Title of Change:	SO16 Package Polyimide Tape Change.
Effective date:	14 Aug 2020
Contact information:	Contact your local ON Semiconductor Sales Office or LengKian.See@onsemi.com
Type of notification:	This Product Bulletin is for notification purposes only. ON Semiconductor will proceed with implementation of this change upon publication of this Product Bulletin.
Change Category:	Assembly Change
Change Sub-Category(s):	Manufacturing Process Change

SOIC-16 Opto coupler PI Tape Qualification

Description of Change (From) :

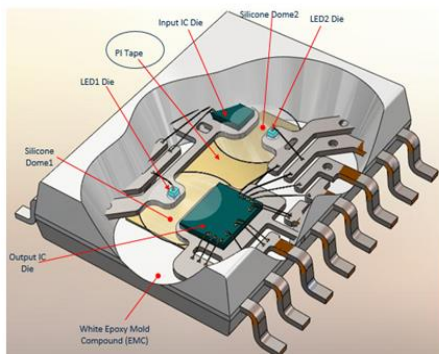
Type A polyimide (PI) tape within the package.

A new improved type B polyimide (PI) tape within the package.
